C2542x MAIN FIRMWARE RELEASE NOTES

WM-Ai & WM-Ai-P Auto Wrappers and IP-Ai Pre-Pack Scale

The previous Ishida WM-Ai/IP-Ai firmware **C2150x** has been superseded by firmware **C2542x**.

Weighed PLU

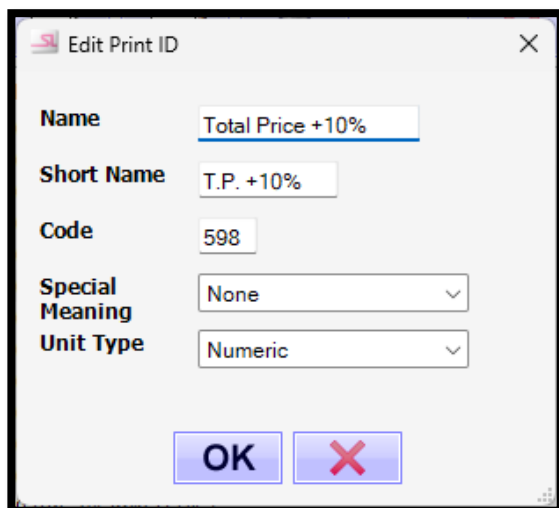
6. Added two Print ID fields:
 - a. 256 (598 in SLP-5): +10% Total Price

- b. 257 (599 in SLP-5): +10% Unit Price (calculated from dividing +10% Total Price by weight)
- 7. SLP-5 must be updated to support the two new Print ID fields. The new Print IDs are added as follows:
